This letter serves to advise the County that revisions have been prepared to address the Design Review comments to #PLP18-0013, delivered by Scott Orr, dated 03/07/2018.

Revisions to the scope of work enhance the previously-approved Development Plan for improvements proposed at 18285 Sonoma Highway, Sonoma, CA 95476, aka *Boyes Springs Food Center Mixed-Use Redevelopment*.

# DESIGN REVIEW COMMITTEE RECORD OF ACTION

**Item No:** 1  
**Time:** 1:30 PM  
**File No.:** PLP18-0013  
**Applicant:** Tim Sloat for KS Mattson Partners LP  
**Staff:** Scott Orr- Project Planner

# Tree Location Map

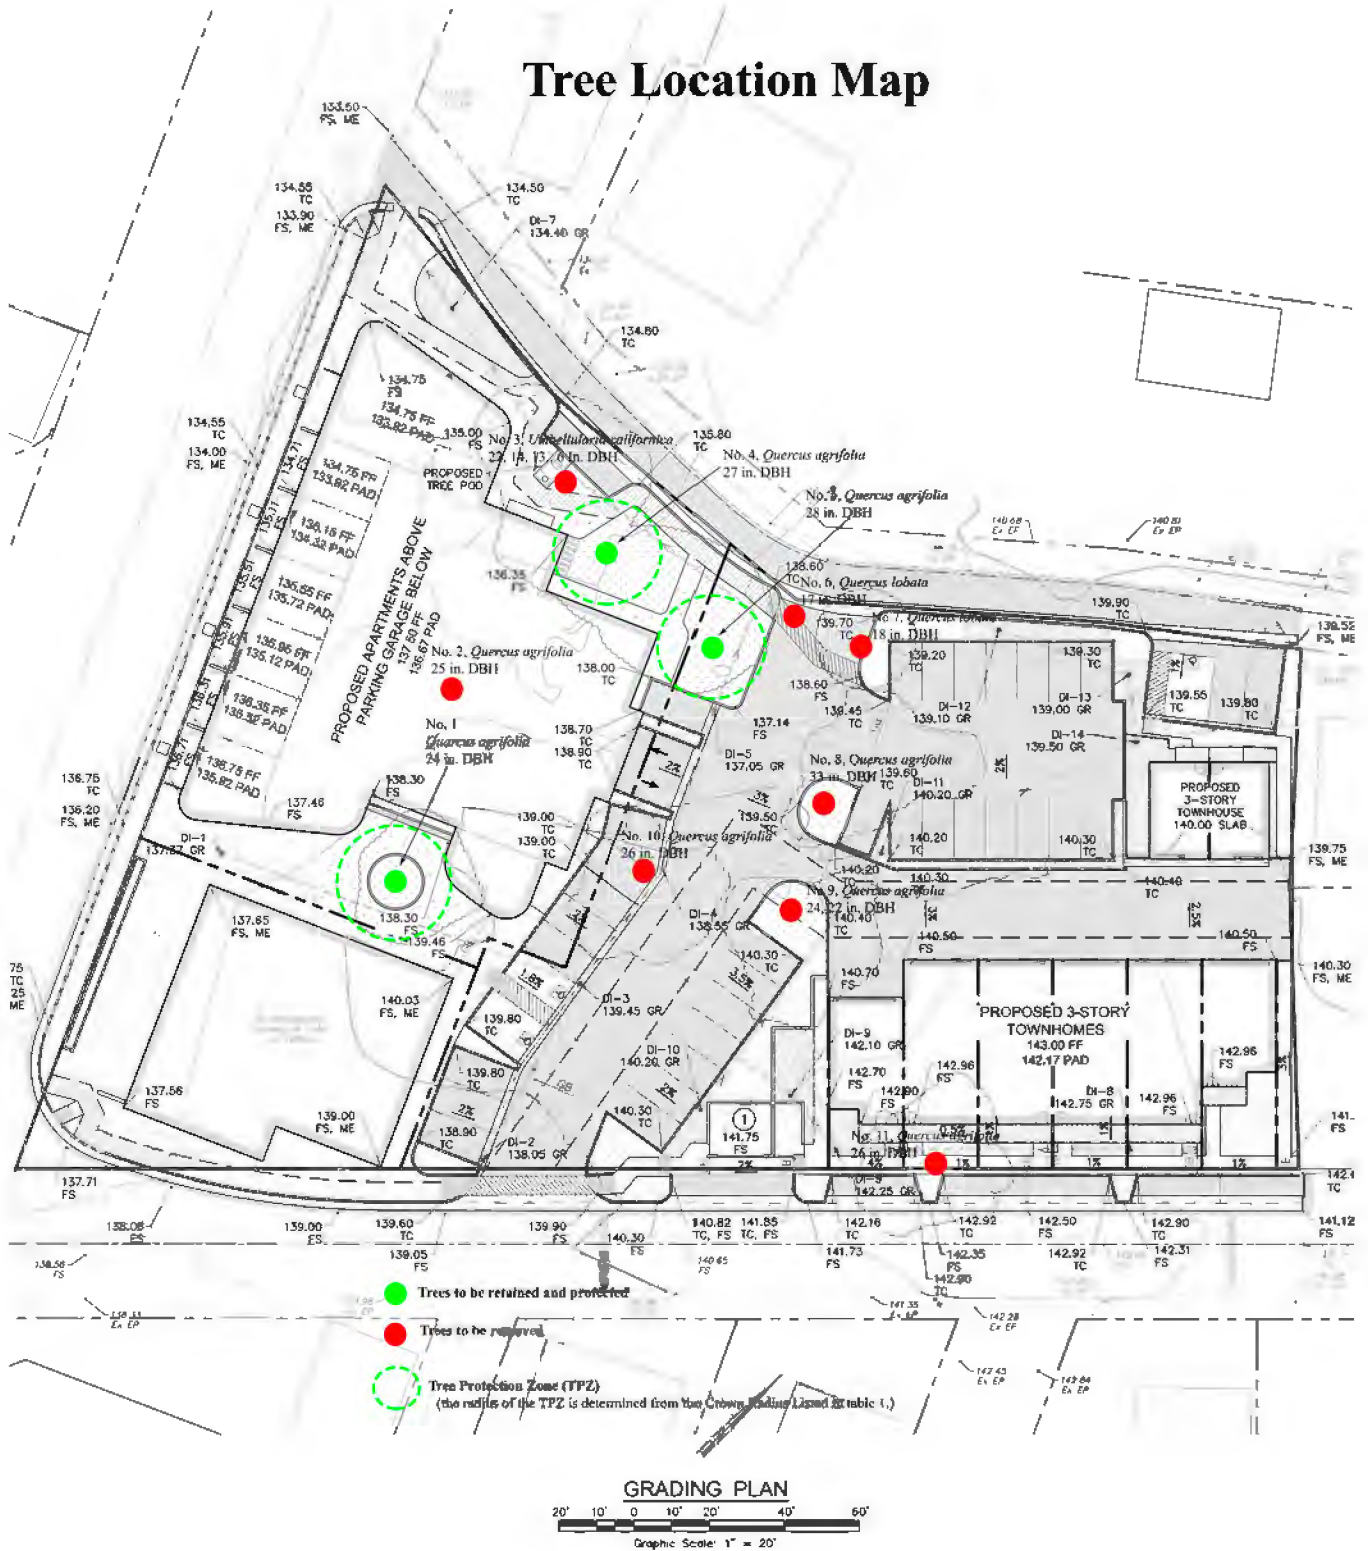
The Tree Location Map page 4 shows the location and disposition of trees within the proposed grading plan. Because the property is planned as a mixed use, high density development, the opportunity to retain

Within the current site plan, tree's Number 1, 4, and 5 have sufficient room to be protected. The map on page 4 shows the location of each tree and the delineation of the recommended Tree Protection Zone (TPZ). The TPZ's are based on the crown radius measured from the trunk to the most distant point at the edge of the dripline. That radius is then used to form a circle around the trunk. These three trees present the best opportunity for preservation. With some minor adjustment there is sufficient room for these trees to successfully be preserved.

**Tree No. 1:** The proposed well around the trunk needs to be enlarged to more closely match the TPZ. Alternatively, a combination of well enlargement and porous pavers with alternative curbing B (page 6) can be used to accomplish this. As an alternative, to traditional curb detailing, the paving surface can be installed first with anchor stakes to which either treated lumber, or a second concrete pour can be attached.

**Tree No. 4:** Some minor adjustments in the location of the sidewalk would be beneficial, however, hand trenching for footings along the south edge with root pruning should result in minimal impact to tree health. This same recommendation can be applied in the area where the building foundation encroaches into the west side of the TPZ.

**Tree No. 5:** The current site plan shows very minimal encroachment of pavement at the edges of the TPZ. There is a proposed 6 inch SD pipe that will go through the TPZ and if it remains at that location, special mitigations will be required. The Sonoma County Tree Protection Ordinance requires hand digging of trenches through TPZ's. I also recommend the use of either an air-spade or hydrovac to dig trenches through root zones. Both tools prevent damage to fine roots and those that are larger. Some root pruning may be required to fit the pipe below the roots. Root pruning should be kept to a minimum and avoid cutting any roots larger than 2 inches in diameter.

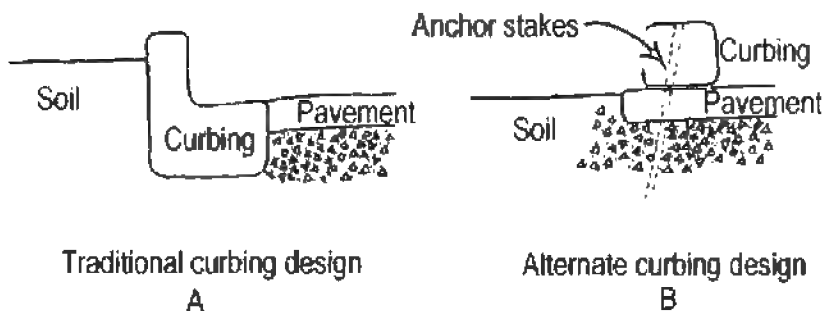
Instead of installing curbing around a parking lot island or median strip in the traditional manner, consider placing the curb on top of the pavement edge.

Traditional curbing design  
A

Alternate curbing design  
B

**A** Curbs designed in the traditional fashion often deflect roots laterally and under the curb. This can result in broken curbs as roots enlarge.

**B** Curbs placed on top of the pavement may allow more roots to grow under the pavement and could be less expensive to install. They can be constructed from concrete, treated wood, or synthetic materials.
